SERVICE BULLETIN

B-032 July 27, 2000

PRODUCT PROGRAM BP7 - EXHAUST HEADER MOUNT RETROFIT KIT **GENERAL** INSTALLATION

Figure 1. Modified Exhaust Mounting System (1999-2000 Models)

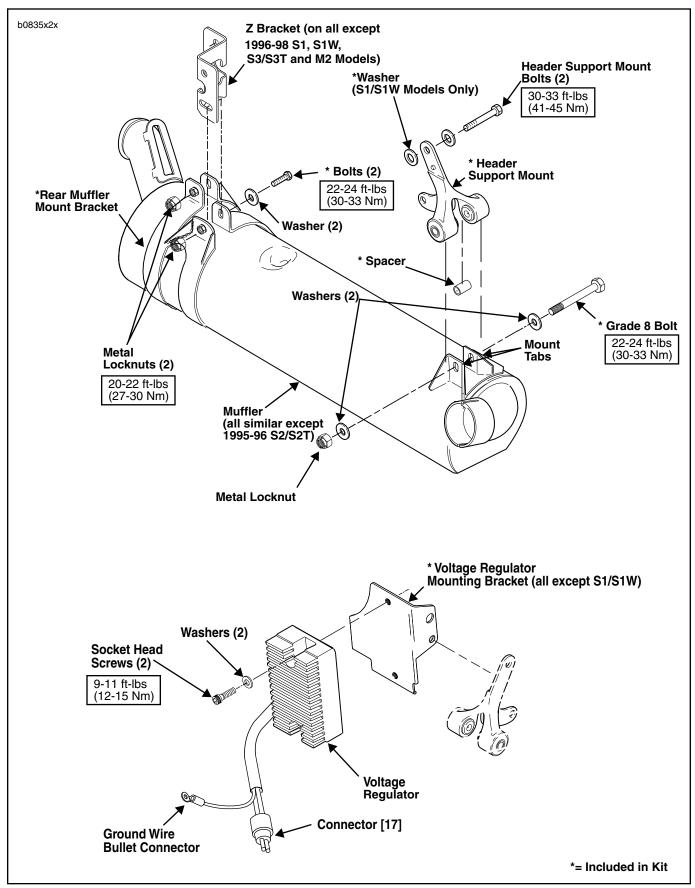
The purpose of this bulletin is to announce the release of a new kit for all 1995-2000 S1, S1W, M2, S2/S2T, S3/S3T, and X1 Model Buell motorcycles and to provide installation instructions. Buell Motorcycle Company has developed this kit as an upgrade to the exhaust header mounts currently in

- 1999-2000 Models Only: See Figure 1. Remove and discard muffler mount from rear of muffler and install new muffler mount.
 - Remove two screws, lockwashers and washers from rear exhaust mount and Z bracket. Discard screws and lockwashers. Retain washers for reuse.

- b. Push rear of muffler down slightly and remove (slide off) and discard original rear muffler mount bracket.
 - c. Slide **new** rear muffler mount bracket over muffler and install with two **new** grade 8 bolts (provided in kit), original washers and **new** metal locknuts. NOTE: Install two metal locknuts over weldnuts on right side.

- Tighten rear muffler mount bracket bolts to 22-24 ftlbs (30-33 Nm).
 - e. Tighten rear muffler mount bracket metal locknuts to 20-22 ft-lbs (27-30 Nm).

Figure 2. Original Exhaust Header Mount (1999-2000)

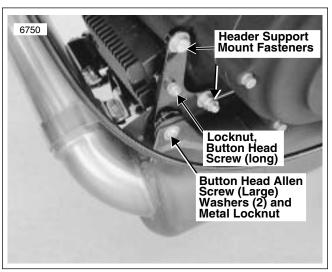
- 6. See Figure 3. Position bottle jack under swing arm mount block and raise motorcycle just enough to unload rear suspension (rear wheel remains on lift).
- Remove and discard header support mount from muffler and crankcase.
 - a. See Figure 2. Remove large button head allen screw, two washers and metal locknut from header support mount. Discard screw. Retain washers and locknut for reuse.

- b. See Figure 2. Remove two header support mount bolts, washers, locknuts (if present) and header support mount, allowing shock mounting bracket (attached to front shock eye) to hang free. Discard header support mount. Retain washers and two bolts.
- Inspect muffler inlet, O₂ sensor bung (if present), mounts and fasteners for cracks or damage. Replace damaged parts as required. See Credit Procedure.

Figure 5. Header Support Mount (all except S1/S1W)

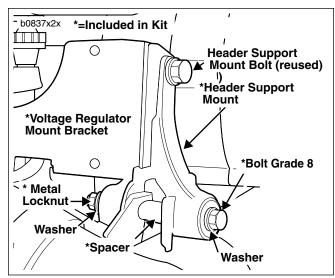
See Figures 1 and 5. Install new grade 8 bolt, original washer, new spacer, original washer and metal locknut to header support mount. NOTE: Spacer goes between front muffler mount tabs.

- 13. Tighten header support mount fasteners.
 - Tighten two header support mount bolts to 30-33 ftlbs (41-45 Nm).
 - b. Tighten button head allen screw to 9-11 ft-lbs (12-15 Nm)

- Tighten front muffler mount bolt to 22-24 ft-lbs (30-33 Nm).
- 14. Lower and remove bottle jack from motorcycle.

Figure 6. Voltage Regulator Revised Mounting

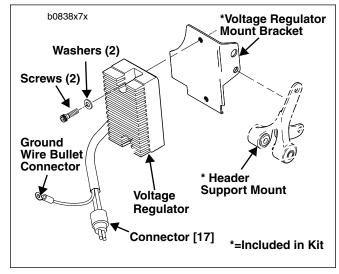
- 15. See Figure 6. Install voltage regulator.
 - a. Install voltage regulator to **new** bracket with original socket head screws and washers. Tighten screws to 9-11 ft-lbs (12-15 Nm).
 - b. See Figure 7. Route voltage regulator wire harness between shock mounting bracket and oil line.
 - c. See Figure 8. Mate connector [17] halves and secure with cable tie.
 - See Figure 6. Connect ground wire bullet connector to main wire harness.
 - See Figure 8. Push connector [17] behind gearcase cover and secure connector [17] to oil pump fitting with cable tie.
 - f. See Figure 8. Secure voltage regulator wire harness to oil line and oil pressure switch harness with cable tie.
- 16. Reconnect battery negative cable to negative terminal. Tighten terminal to specification given in service manual for model being serviced.
